March 2015 Glitch and Fix

The Glitch

The Fix

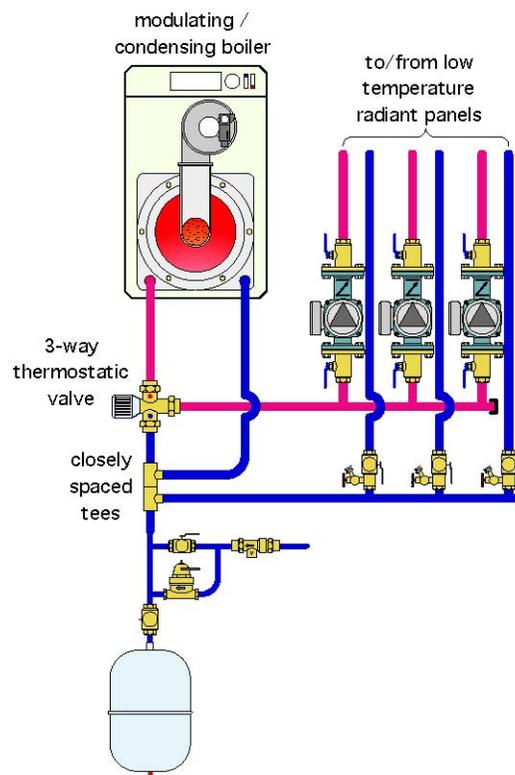
A heating contractor who's trying out his first wall-mounted mod/con boiler installs it as shown below. All flow into the distribution system supplying three radiant panel manifold stations passes through the three-way thermostatic mixing valve. When buying the boiler, the contractor was told to use a pair of closely spaced tees to separate the boiler and distribution system, so he installed some closely spaced tees as shown.

Although those are closely spaced tees under the boiler, they don't serve to hydraulically separate the boiler from the distribution system.

Another poor choice is to install a three-way thermostatic mixing valve (or any mixing assembly for that matter) between a mod/con boiler and the distribution system. It makes no sense to operate the boiler at a temperature higher than needed by the distribution system and then mix down the water temperature. This reduces the ability of the mod/con boiler to operate with flue gas condensation and thus reduces efficiency.

Furthermore, if that three-way thermostatic valve has a low C_v — which is typical of valves of 1-in. pipe size or less — it's going to act as a significant flow restrictor to the distribution system. Low flow leads to wide ΔT on the radiant panel circuits and very likely to insufficient heat delivery.

It's also likely that very low flow rates through the mod/con boiler will lead to operating problems, especially in boilers with low-mass heat exchangers.

There should be a minimum of 12 pipe diameters (12D) of straight tubing upstream of any circulator. This is not the case in the Glitch drawing but has been corrected, and noted, in the Fix drawings.

Finally, take a look at how the circuit purging valves are installed on the zone returns in the Glitch drawing. In this orientation, the only thing they will be purging is the return manifold.
